FW: R10 lighting plan

Condition 24: Lighting

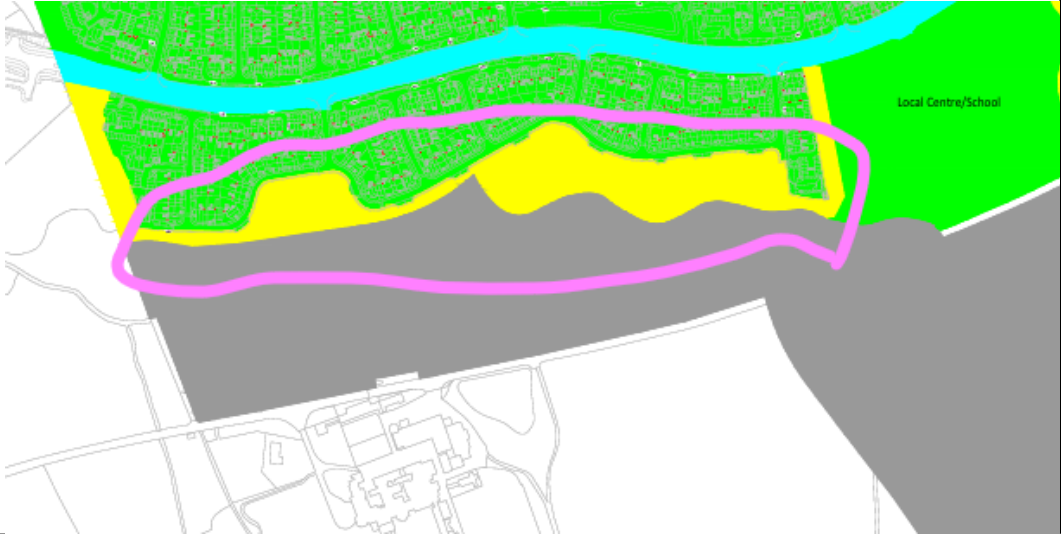
existing woodland, where the extent of adjacent Open Space is limited in depth.
i. Zone 3 SANG proposes that low level lighting bollards can be proposed in designated access footpaths. It is not clear where these designated access footpaths are. Given that the grey area on the whole (see below) matches the SANG boundary and does not include external access footpaths, I am concerned that this zone includes any option for lighting. Natural England has provided consistent advice to the local planning authority that no lighting is acceptable in the SANG. I recommend removal of lighting options in this zone and if there are access footpaths outside the SANG that require bollard lighting these should be identified (broadly) as a separate zone. ii. Zone 3 SANG (grey) needs to match the boundary of the SANG in the northern section of Holme Park SANG – see area roughly circled pink in the image snip below:	This text has been removed. No lighting is proposed in the SANG. SANG boundary has been updated in the drawing.

are aligned. The lux levels are presented at ground level, where they are their lowest. However, in this scenario, the average light level across the surface would be 3.0 lux at ground level, as dictated by BS 5489-1:2020 and BS EN 13201-2: 2015.
Generally, your email below advises that the strategy has been amended to address our comments and that the strategy <i>"includes lighting solutions for adoptable areas, private drives and shared surfaces, apartment courtyards, and links to the public open space"</i>. However, I note that in Section 4, para 4.6 it is still stated that 'shared surface and private drives will be unlit'. This sentence should therefore be removed, and it should be made clear that lighting for the Zone 1 residential areas includes all street types as well as apartment courtyards, as mentioned in your email. Therefore, the Zone 1 paragraph on page 8 and the Zone 1 table on page 9 will need amending in this regard. I also note that on the Appendix 2 lighting strategy plan, there are a few areas on the R10 parcel which are coloured grey, whereas they should be green as they lie within the Zone 1 residential area.	Text has been amended to reference shared surfaces, private drives, apartment courtyards and links to public open space The grey shading was a hatch from the block paving, this has been turned off.
